Venice Neighborhood Council

Land Use & Planning Committee LUPC STAFF REPORT

City Case No: DIR-2025-2758-CDP-MEL-HCA
DIR-2025-2733-CDP-MEL-HCA
DIR-2025-2757-DEP-MEL-HCA

Address of Project: 1166 Garfield Ave
1165 Van Buren Ave
1161 Van Buren Ave

WEST ELEV. (GARFIELD AVE.)
SCALE: 1/4" = 1'-0"

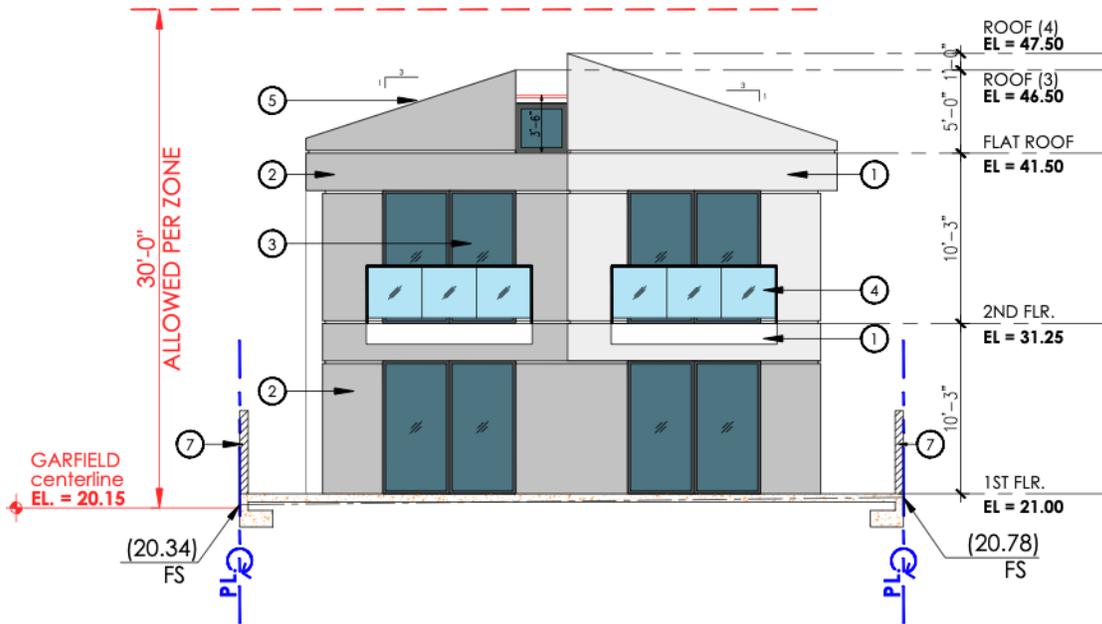
- b. **Using different colors and materials between the three homes and make street-facing façade changes, to vary the architectural design.**

The projects comply with the certified LUP development standards for height and density and with the LAMC for side yards. As such, the projects will not harm the character of the Special Coastal community of Venice. However, the proposed projects on each of the 3 lots are matching in design, which does not protect Venice's architectural diversity. However, the location of the projects adjacent to Lincoln Blvd and the benefits of the project outweigh this concern.
